DATE: March 18, 2014
ADDENDUM NO: 3
PROJECT NO: 40-00372
OWNER: City of San Antonio
PROJECT: Lou Kardon Park Improvements

TRASH RECEPTACLE PLAN AND ELEVATIONS

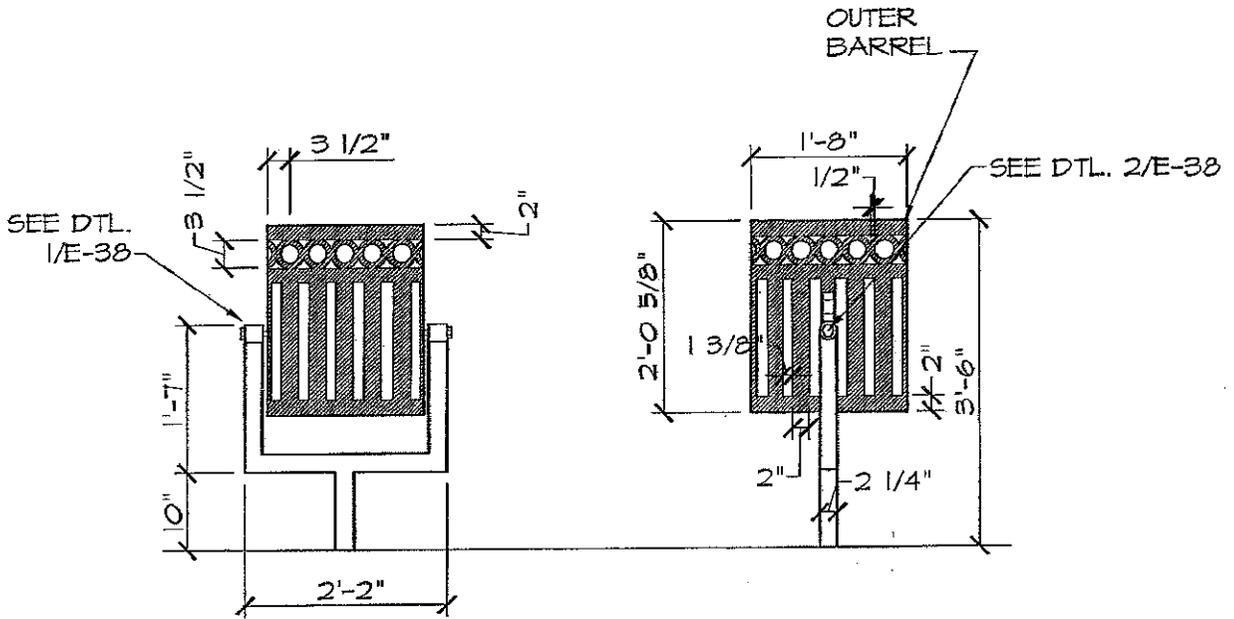
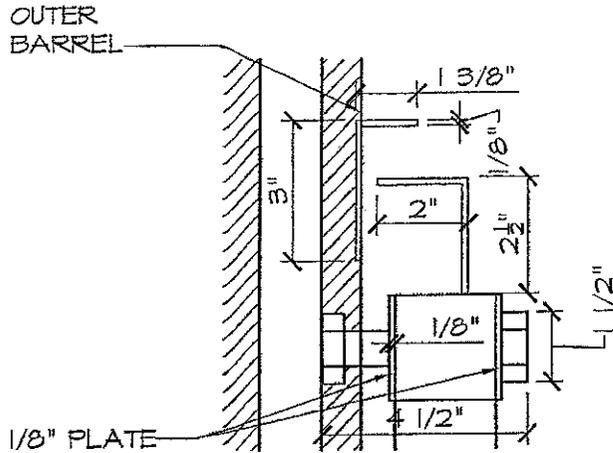
ITEM NO. 1 (2) trash and (2) recycling receptacles are now included in the base bid. One trash and one recycling receptacles will be located at the base bid park tables location adjacent to the concrete pad of the park tables. The remaining trash and recycling receptacle to be located between the two relocated benches at the playground.

Detail of trash receptacle and locking mechanism attached (LouKardon-Trash-Receptacle-Detail.PDF).

1 TYPICAL UNDERGROUND CONDUIT DUCTBANK DETAIL
SCALE: NOT TO SCALE

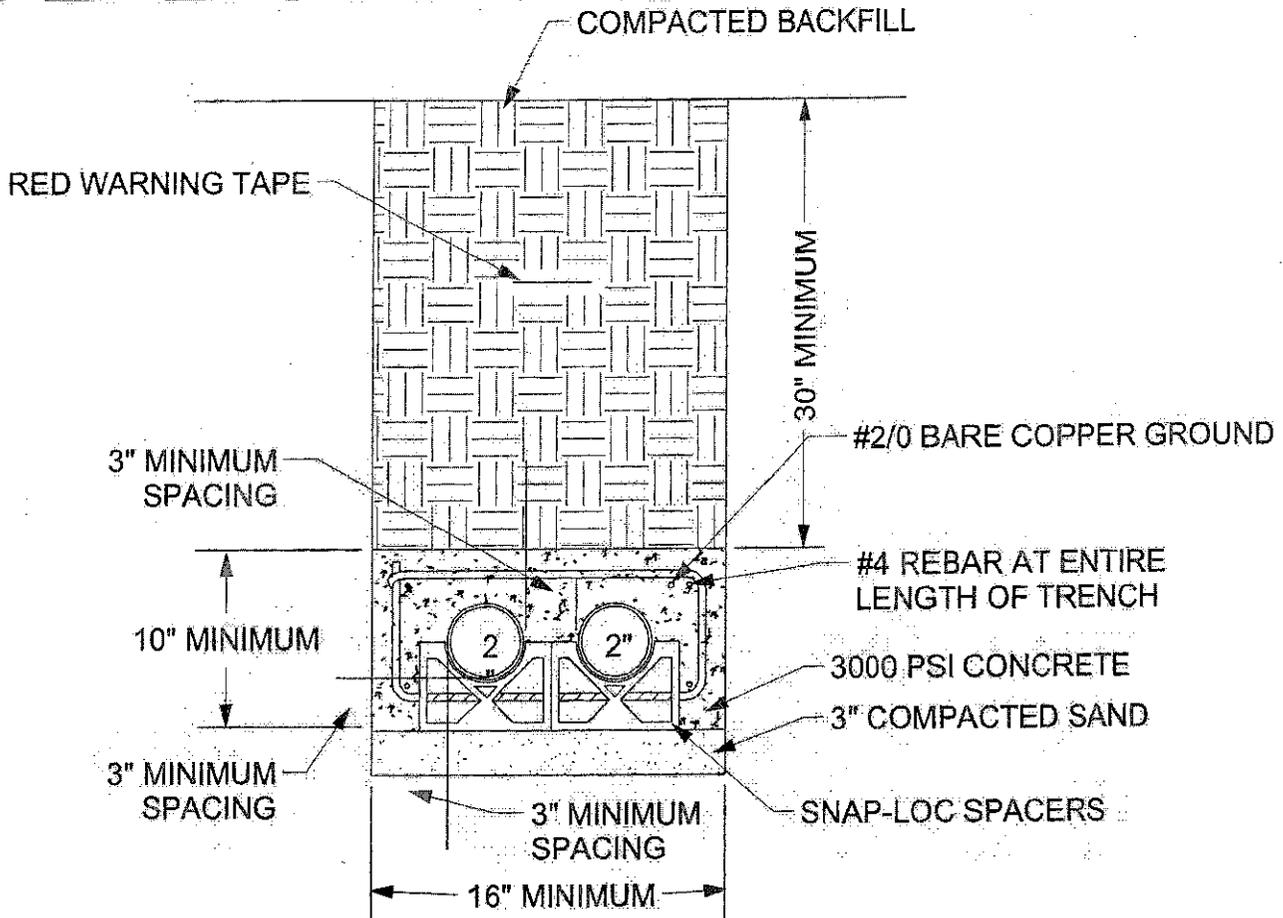
ITEM NO. 2 There seems to be some discrepancies on the underground electrical duct bank fill and back fill requirements for branch circuits to light fixtures. Please advise.
Response: Reference attached typical underground conduit detail for requirements. (Ductbank.PDF)

1. PROVIDE CARLON, SNAP-LOC SPACERS ON 6'-0" CENTERS.
2. PROVIDE BEADED STRAP AND LOCKING KEY WAY FOR CONDUITS MOUNTED ON TOP OF SPACER RACK.
3. TOP OF CONCRETE CAP TO FINISHED SHALL BE A MINIMUM OF 30"
4. CONCRETE MIX SHALL CONTAIN RED DYE AT 8 LBS. PER CUBIC YARD OF CONCRETE.
